In the matter of the Proposed Porirua District Plan

Reply by Gregory Martin Vossler and Ian Alexander Bowman – Hearing

Stream 7 - on behalf of Porirua City Council to feedback sought by the Hearing

Houses at 4, 8 and 10 Kenepuru Drive

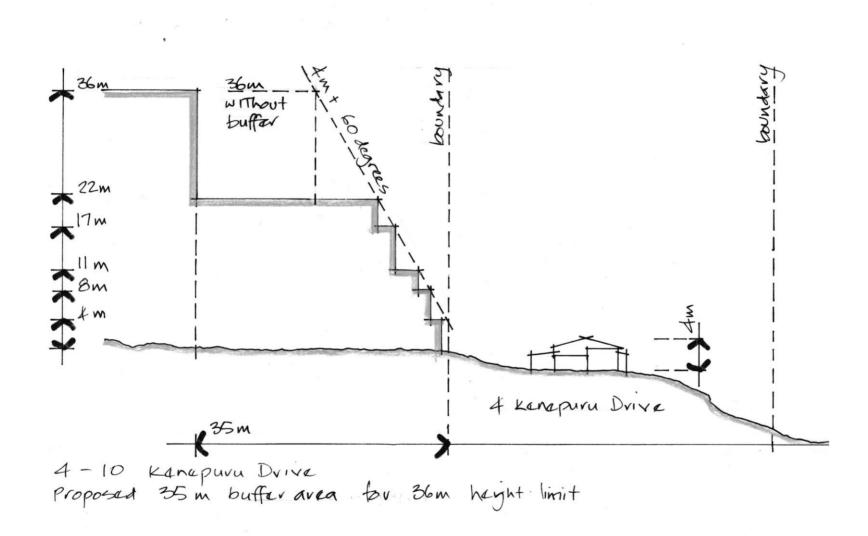
Based on the site visit and further consideration of the likely effects of the recommended height uplift we have concluded that, in the absence of adequate mitigation, the proposed increase in the maximum height from 22m to 36m on the sites to the west and south of the heritage items would have a major effect on the relevant heritage values of these items. In particular we consider that the increase in height enabled will:

Be significantly more visually dominating;

- Distract from the landmark and visual qualities of the three heritage items;
- Reduce the integrity of the inter-related setting of the heritage items; and

- Create a less sympathetic backdrop to the heritage items from major viewing points to the east (e.g. the Titahi Bay Road bridge).
- This is further illustrated and reinforced by the diagrams prepared by Ian Bowman included in Appendix 1 of our reply.

- Although we recognise and support, in principle, the intent underlying the recommended height uplift we are of the view that this needs to be moderated by proportionate measures to mitigate the likely effects on the heritage items at 4, 8 and 10 Kenepuru Drive.

- 14 Consequently, we would recommend the establishment of a 'buffer' area surrounding these heritage items comprising the following:
 - A 35m 'buffer' to the west of the rear boundaries of 4 12 Kenepuru
 Drive; and

- The 7th Day Adventist Church site to the south of 12 Kenepuru Drive.

To assist the Panel the spatial extent of the 'buffer' area is diagrammatically illustrated in Appendix 2 of our reply.

- 15 The intention of the 'buffer' is that the requested 36m height variation control would not apply within the areas outlined above and illustrated in Appendix 2 for the reasons outlined in paragraph 11.
- In our view this recommended 'buffer' would provide a necessary and effective transition from the existing scale of development on the subject heritage sites to that enabled over the balance of the
